UNITED STATES PATENT AND TRADEMARK OFFICE

Office Action Summary	Application No. 10/568,844	Applicant(s) CURCHER, DENNIS	
	Examiner Erica E. Cadugan	Art Unit 3726

DETAILED ACTION

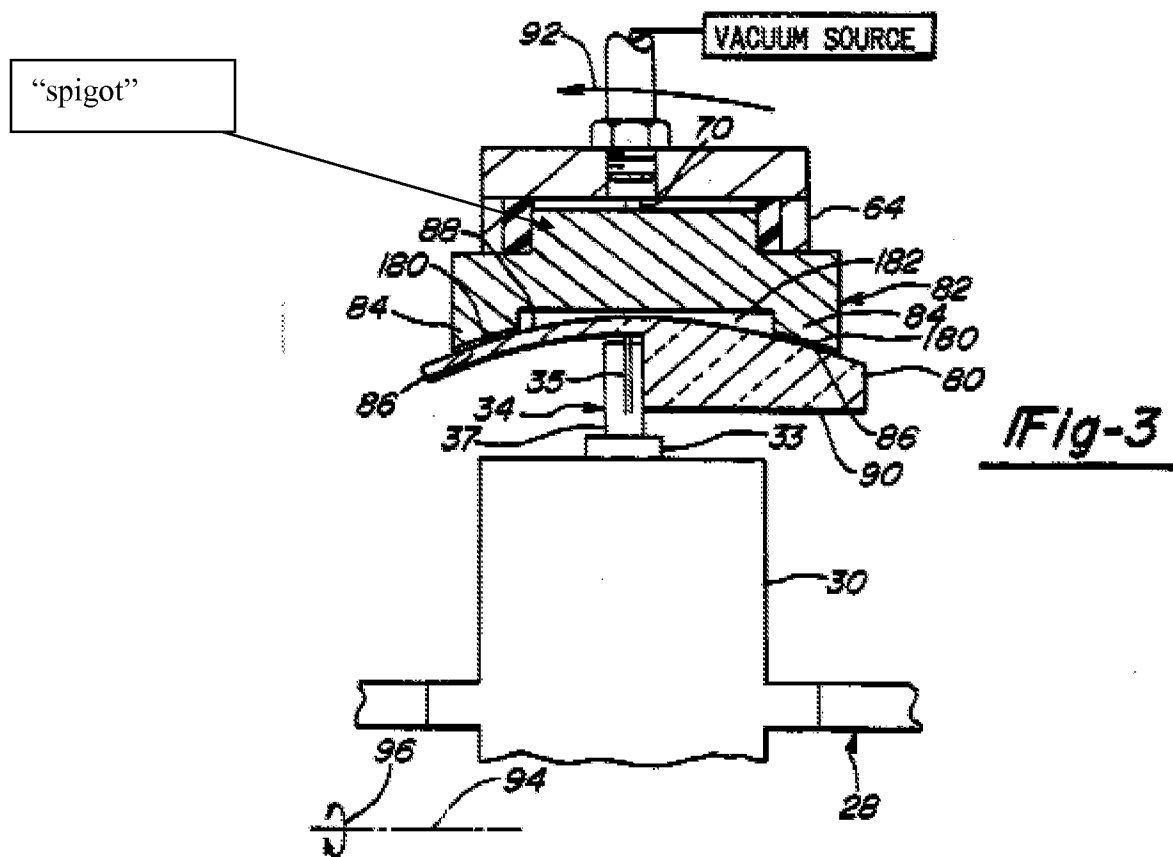
The “jig” taught by Cliber includes a “carriage”, such as 64, that includes the “lens holder” 66 for holding a lens member 80 (Figures 2-3, col. 4, lines 58-59). While it is noted that

it does not appear that such is necessary to meet the present language of the independent claims, noting that the independent claims are directed to the “jig”, it is noted that Cliber does teach that the lens member 80 has a “mounting block” 82 “bonded” to a convex surface thereof (with double sided adhesive tape 180; see Figure 3 and col. 7, lines 24-29, for example).

Regarding claim 5, note that the mounting block 82 has a “spigot” (labeled in the reproduction of Figure 3 below). Note that the spigot fits into a “socket” of the lens holder (see Figure 3).

Regarding at least claims 5-6, note that Cliber teaches a vacuum source for applying a vacuum to the “underside” of the spigot to hold the spigot in the socket (see Figure 3 and col. 4, lines 48-57).

Regarding at least claim 7, note that Cliber explicitly teaches the use of plural locating pins 70 (Figure 3 and col. 4, lines 50-52), which plural pins, by virtue of their location and engagement between the socket and the spigot, would inherently act to ensure that the spigot does not revolve in the socket (see Figure 3 and col. 4, lines 50-52).
